# Intel<sup>®</sup> Celeron<sup>®</sup> Processor Specification Update

Document Number: 243748-042

The Intel<sup>®</sup> Celeron<sup>®</sup> processor may contain design defects or errors known as errata, which may cause the product to deviate from published specifications. Current characterized errata are documented in this Specification Update.

**Figure 1 Celeron® on 0.13 Micron Processor 256K Platforms Workaround**

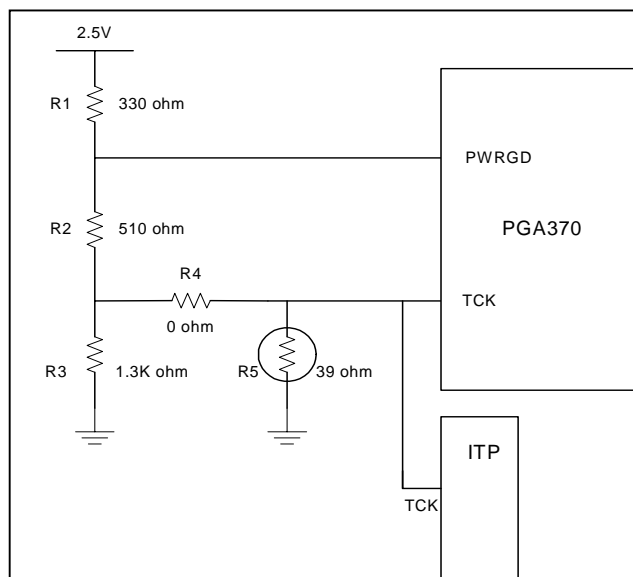
**Workaround:** To prevent the risk of power-on boot failures or catastrophic thermal failures, a platform workaround is required. The system must provide a rising edge on the TCK signal during the power-on sequence that meets all of the following requirements:

Please note, the example workaround circuits attached require circuit modification for ITP tools to function correctly. These modifications must remove the workaround circuitry from the platform and may cause systems to fail to boot. Review the accompanying notes with each workaround for ITP modification details. If the system fails to boot when using ITP, issuing the ITP 'Reset Target' command on failing systems will reset the system and provide a sufficient rising edge on the TCK pin to ensure proper system boot.

In addition, the example workaround circuits shown do not support production motherboard test methodologies that require the use of the processor JTAG/TAP port. Alternative workaround solutions must be found if such test capability is required.

For Production Boards:  
*Depopulate R5*
